Ref: Grange Paddock, Ickleton Road Elmdon, S62A/2023/0015: additional permitted comments on the Essex County Council Ecology & UDC Landscape reports

A: The Essex County Council Ecology Report:

B: The UDC Landscape Report

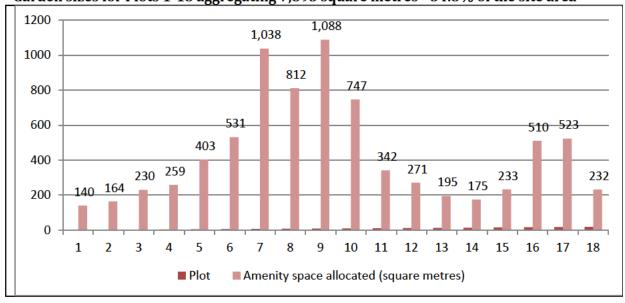
- ❖ Ms. Gibbs rightly notes how there are discrepancies between the PEA and AIA with regard to 2 Horse Chestnut trees proposed to be removed, with the latter's reporting of this not picked up on in the former. However, she then expresses the view that these 2 trees are "unlikely to be suitable for roosting bats". This instant dismissal of matters needs to be contrasted with the Bat Conservation Trust (see www.bats.org.uk) which notes that: "Trees such as oak, beech and ash are particularly suitable for bats, but any woodland or tree has potential for a bat roost – especially if it has cavities in the trunk or branches, woodpecker holes, loose bark, cracks, splits and thick ivy". I live within a quarter of a mile of this site and green woodpeckers are a very common sight so that woodpecker holes are a racing certainty. The remarks of the BAT Conservation Trust also need to be seen in the context of the widespread scale of the tree felling required for the proposed access road. I therefore reproduce below a Table that was included in my objection letter dated the 5th of March 2023. Observe how 10 ash trees would be felled which, as per the BAT Conservation Trust, are especially **favoured for roosting by bats.** There are incidentally 3 Horse Chestnut trees overall that would be lost:

Chainsaw Alley – a summarised version
